STAFF REPORT: 04/10/2024 REGULAR MEETING

APPLICATION NUMBER: HDC2024-00121

ADDRESS: 19690 SHREWSBURY

SCOPE: DEMOLISH GARAGE, ERECT GARAGE AND DECK

Site Photo 2, by Staff March 27, 2024: (West) front elevation of garage, showing foundation cracks, bowing of center roof, and some efflorescence and cracks in the masonry.

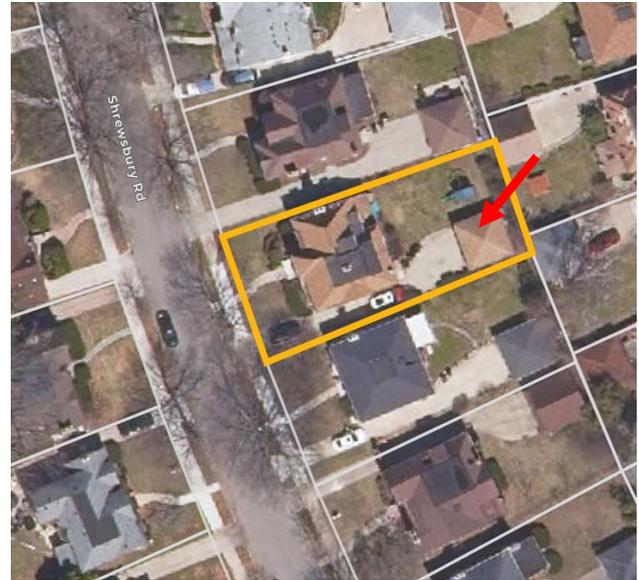
- Staff visited the site with the owner and observed the garage’s conditions inside and outside. Staff observed that the general condition of the property has been draining towards the garage and that there is substantial foundation damage in the concrete slab and on the sides of the garage, which contributes to a slight bowing of the main garage door lintel. Step cracking can be observed along the north and south mortar joints of the walls, especially near the foundation. Some efflorescence is evident as well as “rising damp” as the internal wood framing pulls moisture from the ground surface up into the lower walls. The rear wall from the exterior appeared to have little to no damage. The roof had previous support work completed, and the exterior roof appears to need new shingles. Staff’s initial assessment was that the foundation was failing and requested the applicant to provide the option for an assessment on restoration of the garage, looking at alternatives, perhaps lifting and restoring the foundation of the garage.

- **Foundation:** Upon assessment of the foundation, cracking and displacement of below-grade foundation are likely present and have caused resultant cracks and shifting in above grade brick wall. This may be due to frost heave during unseasonably cold winters where frost depth exceeded the 42” inch below grade design standard.

- **Slab:** A longitudinal crack in the concrete floor slab was observed and the elevation of the slab measured to be higher along this crack line suggesting damage from frost heave.

- **Walls:**
 - Masonry walls: single wythe brick masonry wall was observed to have vertical cracking indicating foundation issues.

Figure 2., from Applicant, proposed site plan, showing proposed new garage location, driveway, deck and patio.

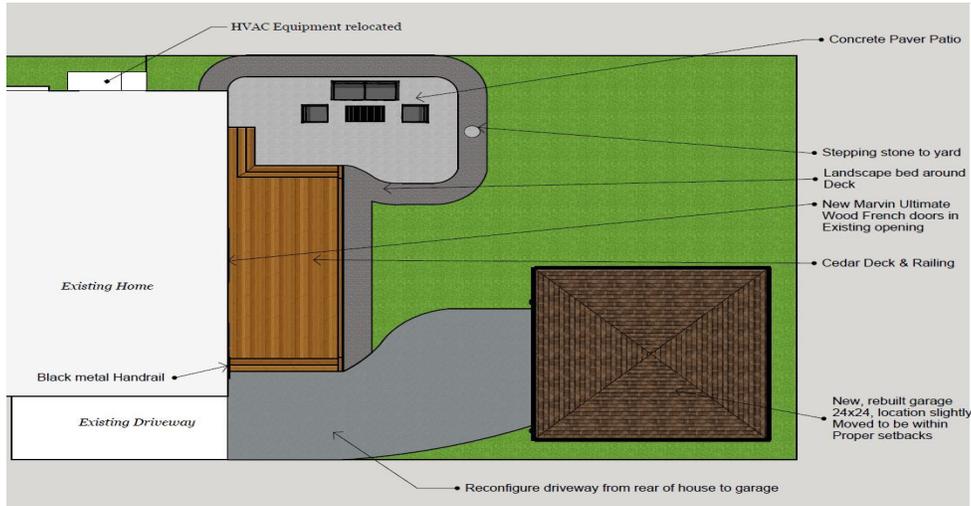
- The proposed cedar wood deck, patio, and landscape are an appropriate design that complements the house. The proposed modification of the driveway to meet the proposed garage is also appropriate in staff's opinion.

It is staff's opinion that the demolition of the demolition of the garage, construction of the new garage, new deck, new patio, driveway and garden bed are appropriate. Staff therefore recommends the Commission issue a Certificate of Appropriateness for the work as proposed because it meets the Secretary of the Interior Standards for Rehabilitation and the Sherwood Forest Historic District Elements of Design.
